ITEM TITLE: MODERATE VISIBILITY CELLULAR TOWER SITE PLAN APPLICATION—
SMARTLINK PCS ON BEHALF OF VERIZON WIRELESS LLC, CASE TYP215-00012

TYPE II TENTATIVE SITE PLAN REVIEW, STAFF REPORT & RECOMMENDED CONDITIONS

Project Name: Verizon Wireless Site Plan Review

A-0

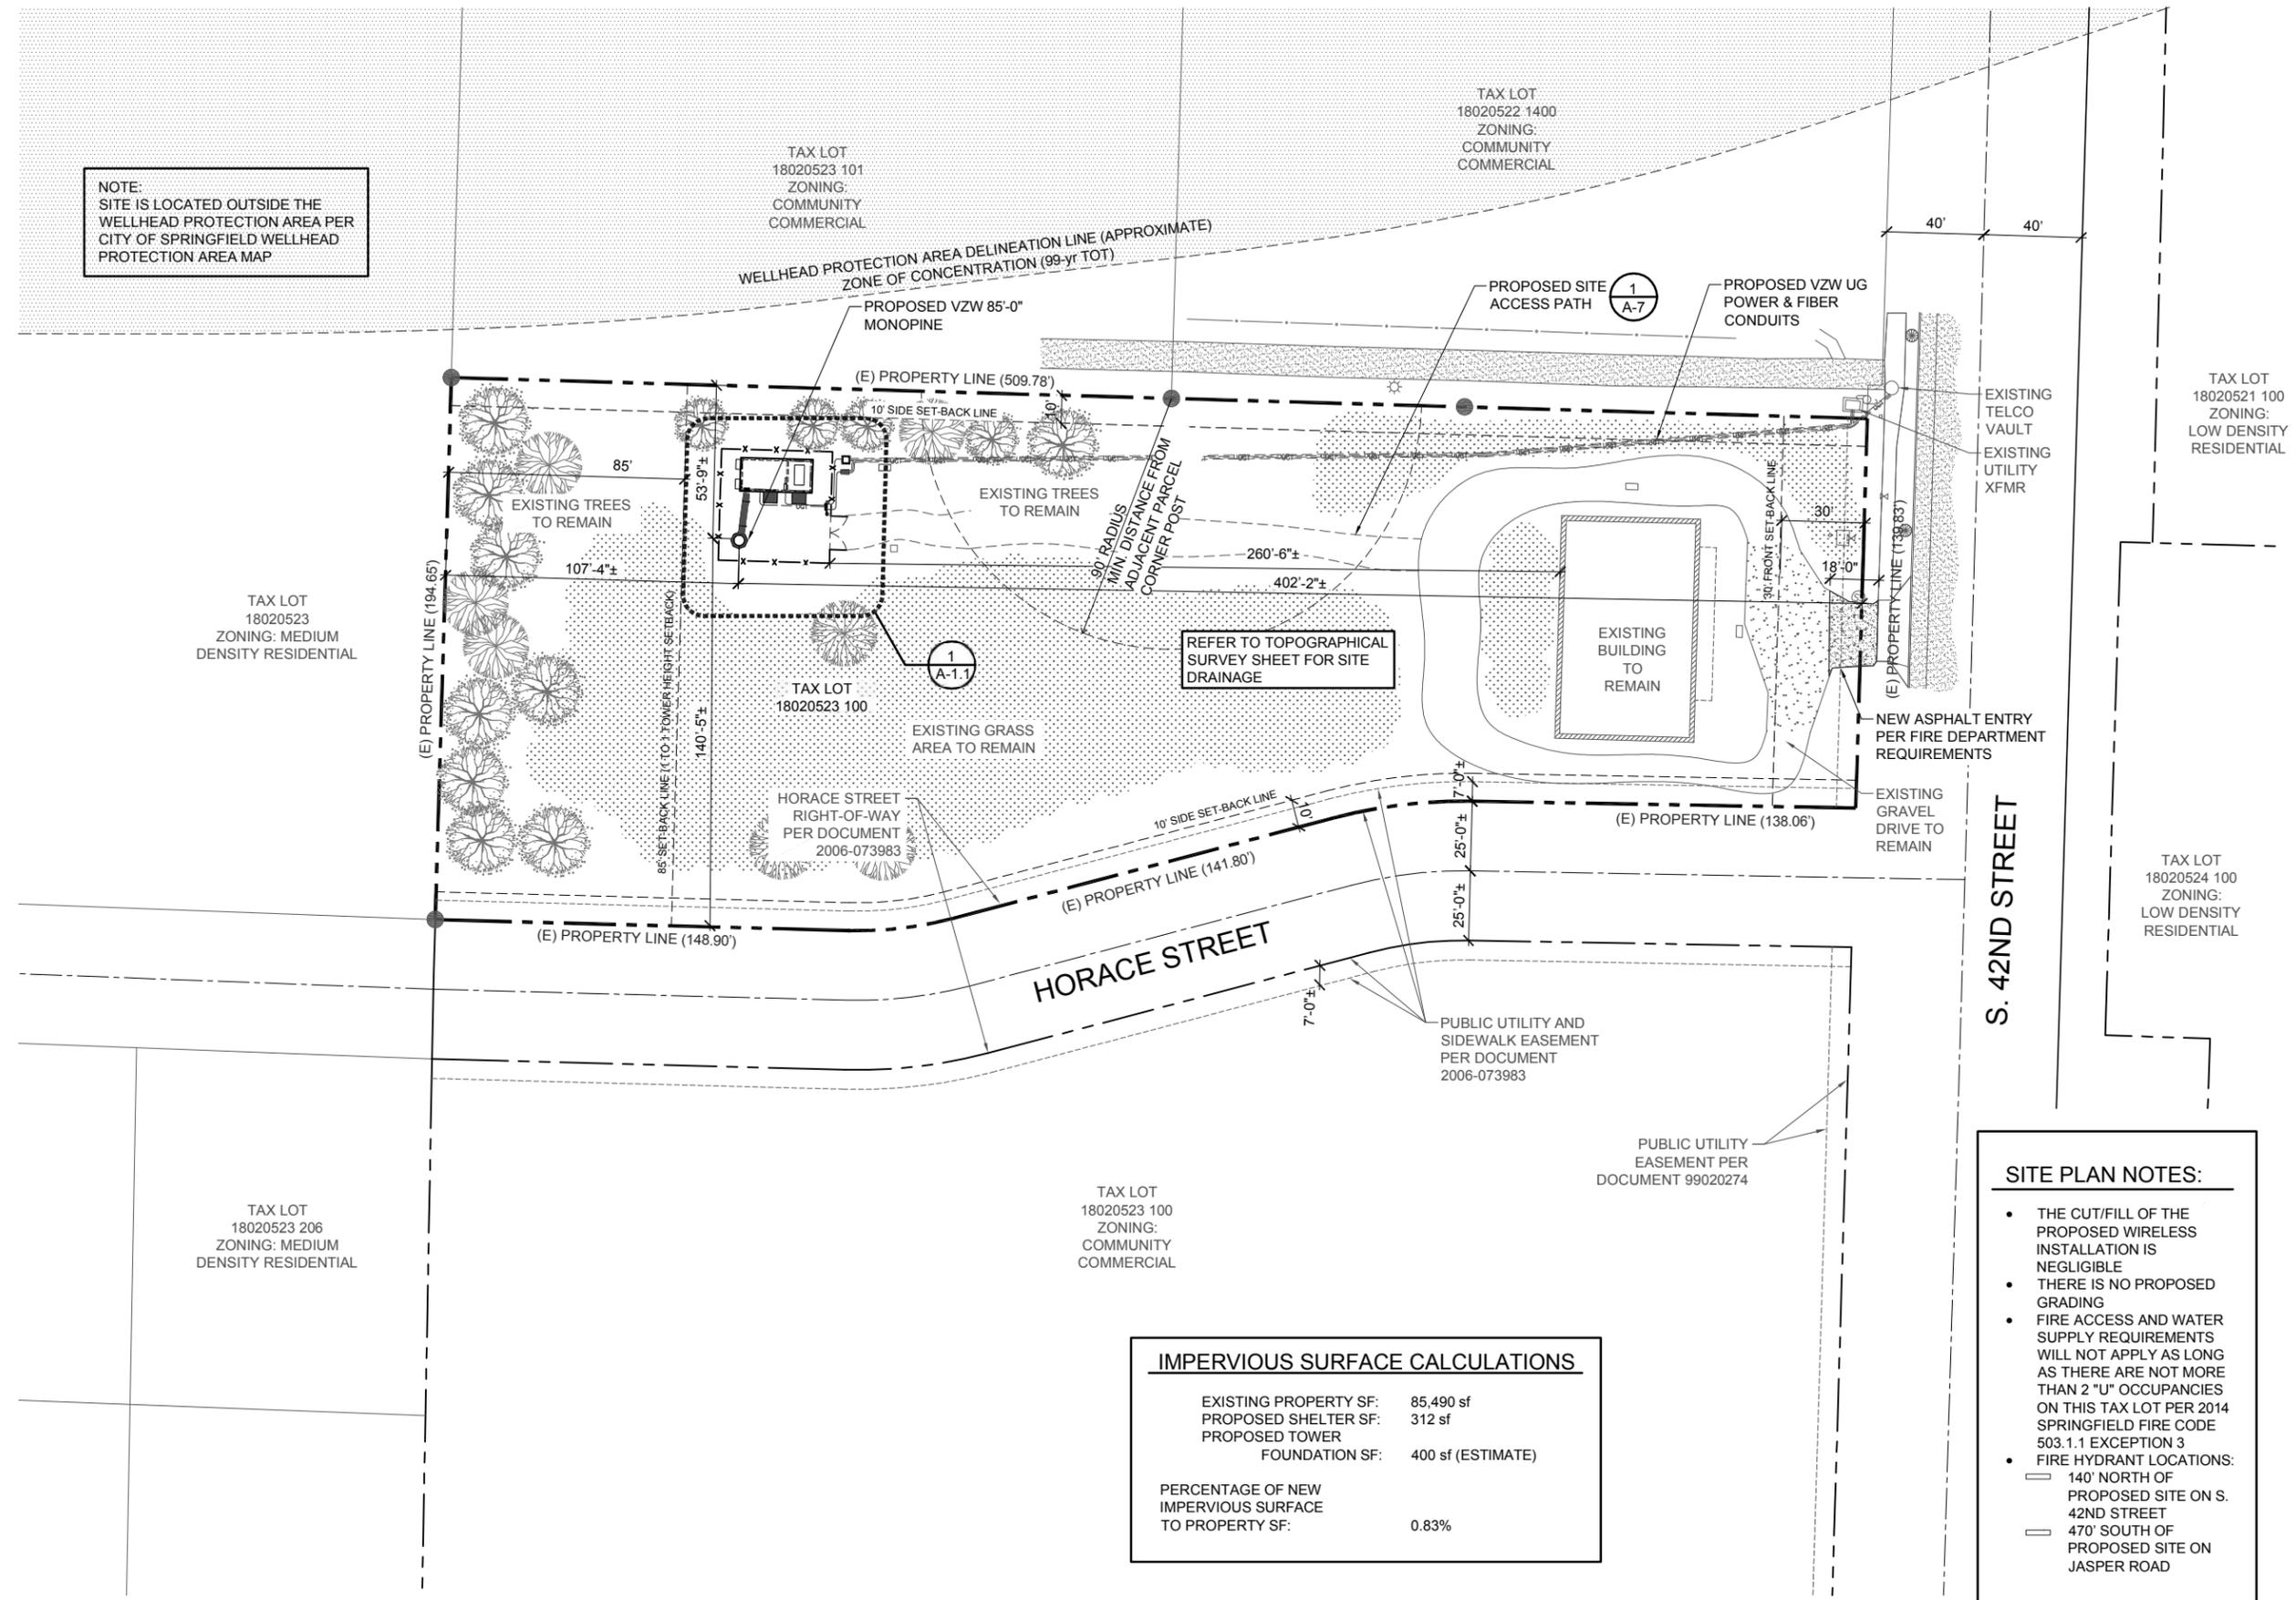
- 4. The Final Site Plan shall provide for a paved driveway apron that extends at least 18 feet into the site as measured from the western edge of the South 42nd Street right-of-way.**
